Access Compliance Report

Public Rights-of-Way

(Curb Ramps)

Intersection ID: 32274	Main Street: MYERS_MILL_LN	Cross Street: WILLOUGHBY_RUN_DR	Location: E
ADA ID: 05C44D32BAD2	Ramp Type: PerpDiag	Initial Pass/Fail: Fail	Overall Compliance: No
Severity Score: 21.25			
Codes/Mitigation Info/Possible Solution		Field Measurements/Component Compliance

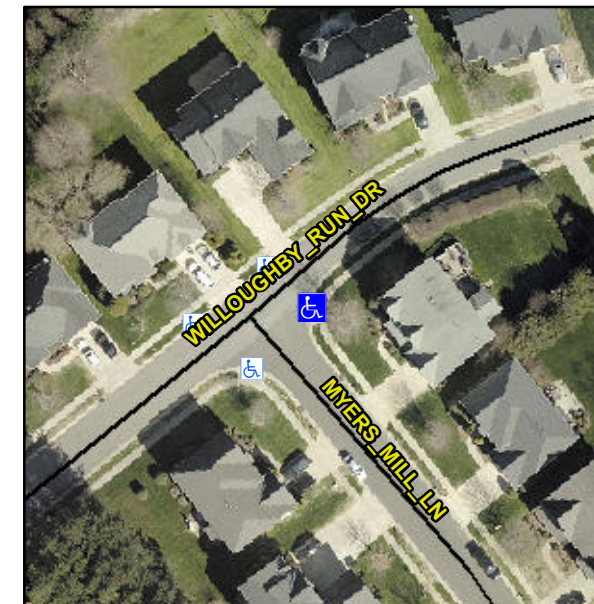
Not Found, R304.5.1, R304.2.2

Compliance	Description	Data	Compliance	Description	Data
N/A	Ramp Length (in)	45.0	No	Ramp Slope (%)	10.0
No	Ramp Width (in)	41.0	Yes	Ramp XSlope (%)	0.2
N/A	Flare Type LT	N/A	N/A	Flare Type RT	N/A
N/A	Flare Slope LT (%)	N/A	N/A	Flare Slope RT (%)	N/A
N/A	Flare Traversable LT?	N/A	N/A	Flare Traversable RT?	N/A
N/A	Landing Length (in)	N/A	N/A	DWS Provided?	N/A
N/A	Landing Width (in)	N/A	N/A	DWS Contrast?	N/A
N/A	Landing Slope (%)	N/A	N/A	DWS Length (in)	N/A
N/A	Landing X Slope (%)	N/A	N/A	DWS Full Width?	N/A
N/A	Landing Curb? (Y/N)	N/A	N/A	DWS Offset (in)	N/A
N/A	Shared Landing?	N/A			
N/A	Gutter Ponding?	N/A	N/A	Gutter Slope (%)	N/A
N/A	Gutter Lip Ht (in)	N/A	N/A	Gutter X Slope (%)	N/A
N/A	Painted X Walk1?	No	N/A	Painted X Walk2?	No
	X Walk 1 Direction	To NW		X Walk 2 Direction	To SW
N/A	X Walk 1 Width (in)	N/A	N/A	X Walk 2 Width (in)	N/A
	X Walk 1 Slope (%)	0.3		X Walk 2 Slope (%)	0.4
	X Walk 1 X Slope (%)	0.9		X Walk 2 X Slope (%)	0.3

Remove & Replace Curb Ramp With Two New Directional Ramps or Equivalent.
